MARK	DATE	DESCRIPTIONS	BY	CH'D	CCO#
1	06/12/08	SERVICE PLATFORM ELECTRICAL CHANGES	RR MP	RG FW	55

CONTRACT CHANGE ORDER NO._____
SHEET_____ OF _____

DETAILS
SAS SUPERSTRUCTURE ROADWAY EASTBOUND PANEL UP-206 SCHEDULE
NO SCALE

E-152

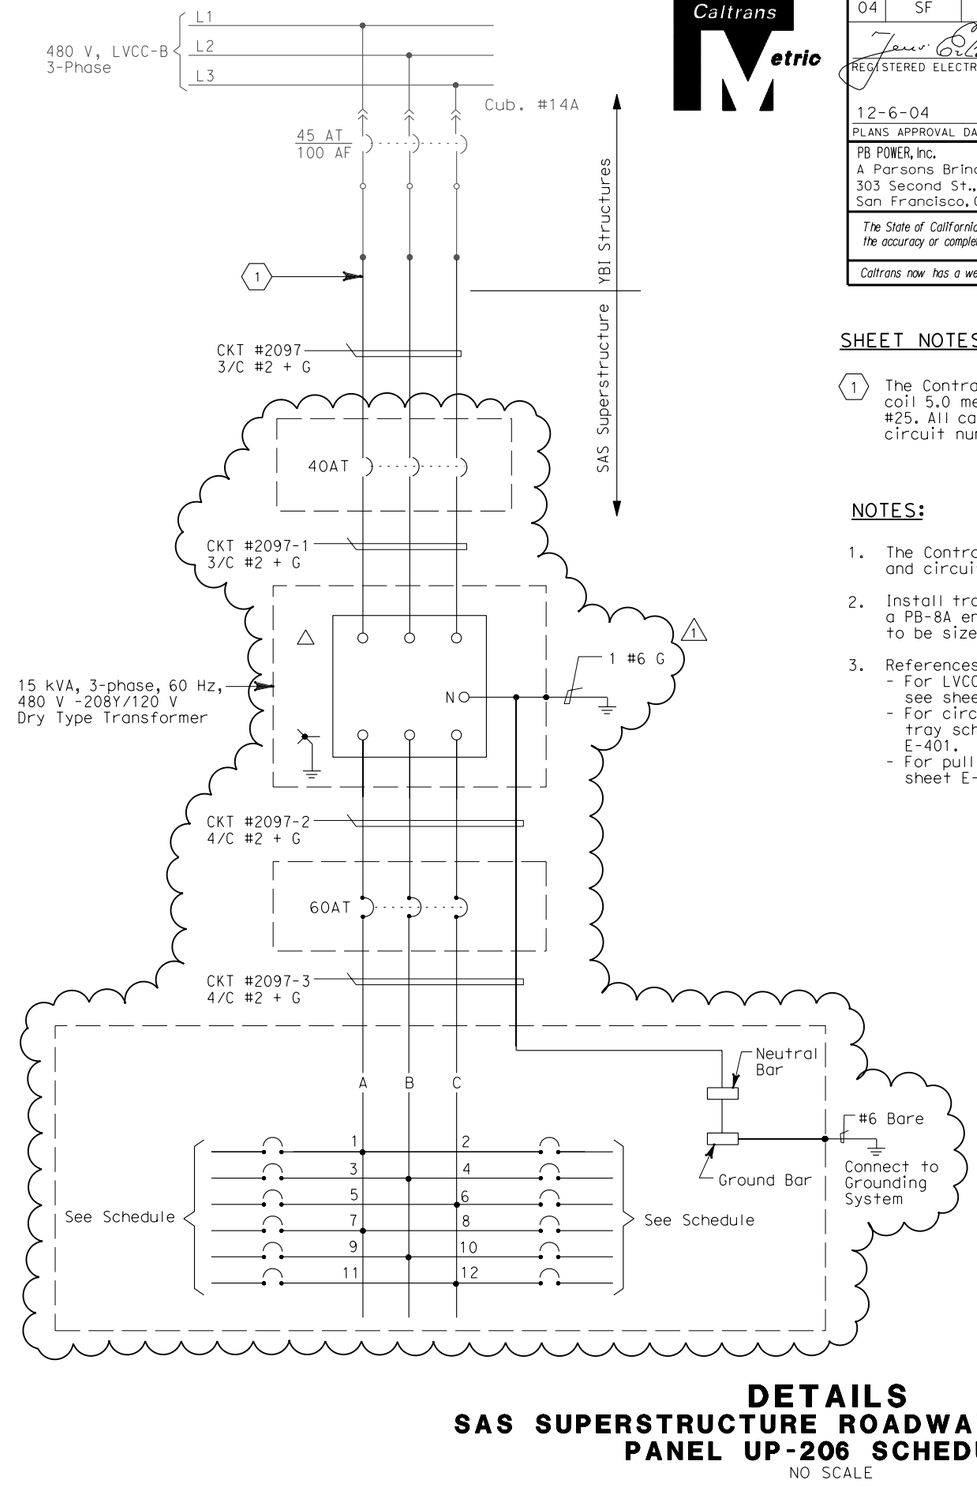
UTILITY PANEL UP-206 (CKT #2097)

LOAD DESCRIPTION	LTG	REC	OTH.	CB		CB	LTG	REC	OTH.	LOAD DESCRIPTION
Recept (2) Eastbound North Barrier		360		20/1	1 A 2	20/1				Spare
Spare				20/1	3 B 4	20/1				Spare
Recept (2) Service Platform #6		360		20/1	5 C 6	20/1	738			Girder Lighting (18)
Recept (2) Girder		360		20/1	7 A 8	20/1	738			Girder Lighting (18)
Navigation Relay Cabinet #NAP-6E			600	20/1	9 B 10	30/1	1		2000	Controller Cabinet #TOS-6EA
Spare				20/1	11 C 12	20/1				Spare
TOTAL VA		1080	600				1476		2000	TOTAL VA
